RCOD #23-03 (79 Parkway Plaza)

11-21-2024 Notes for Applicant (DGL updated comments 12/5/24 & 02/20/25)

PARKWAY PLAZA PROJECT

SHEET NUMBER:
L-1.0

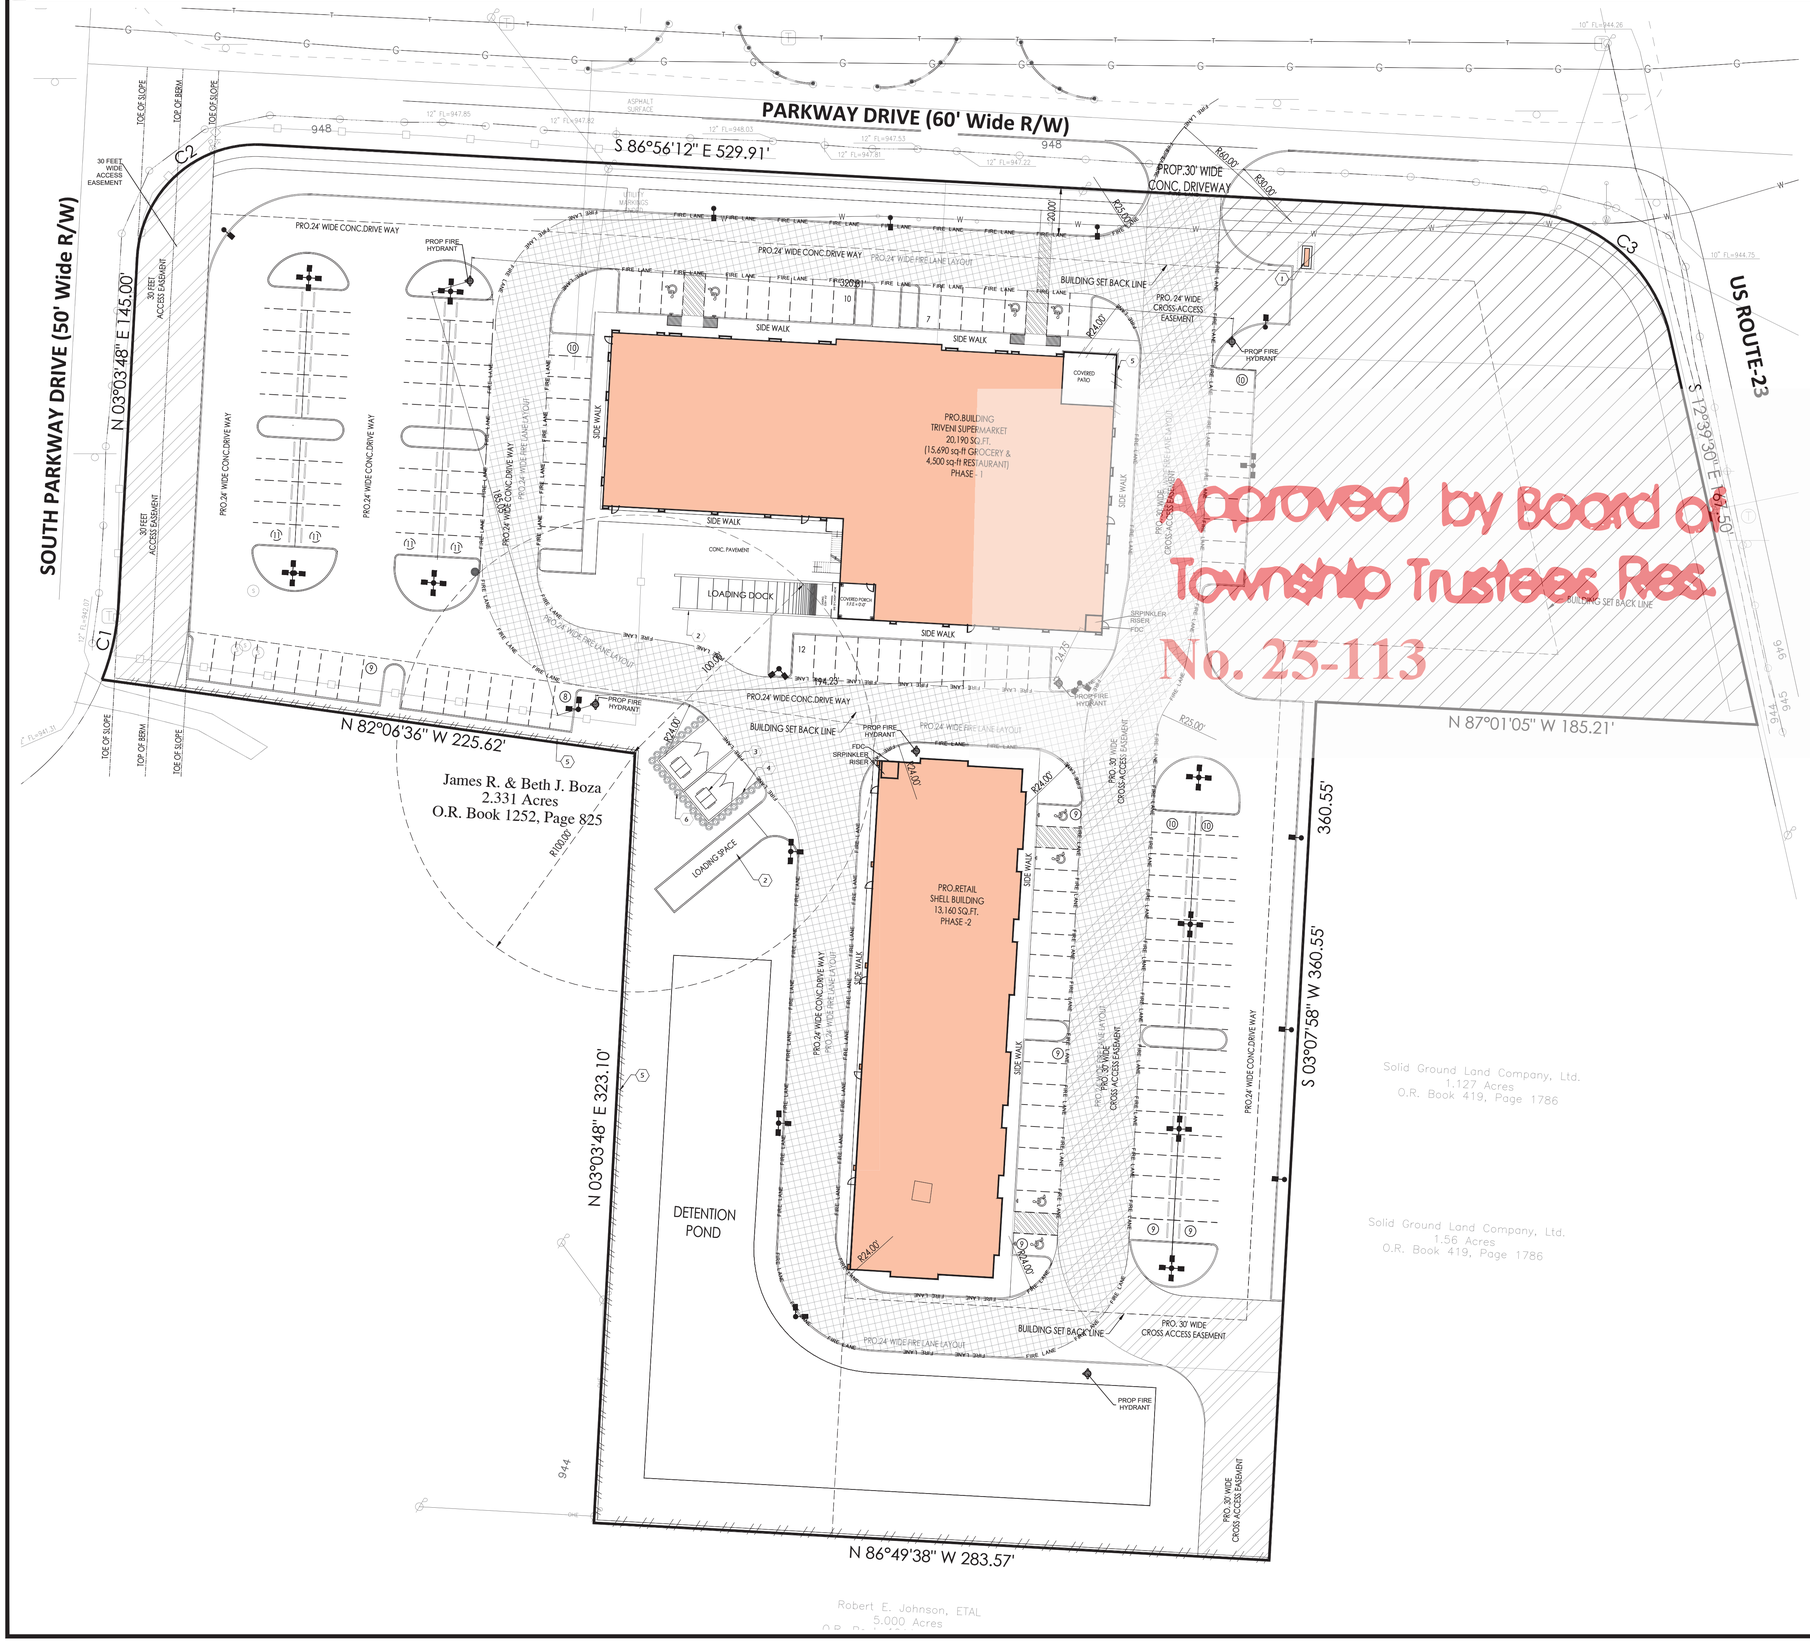
- Remove the sidewalk on the northwest side of the development along S Parkway and prioritize mounding with landscaping/evergreen trees on top of mounding. (Suggested staggering evergreens to create a barrier) **DGL removed the sidewalk & added a mound**. Architect – added more trees that are staggered, please refer to sheet L-1.0
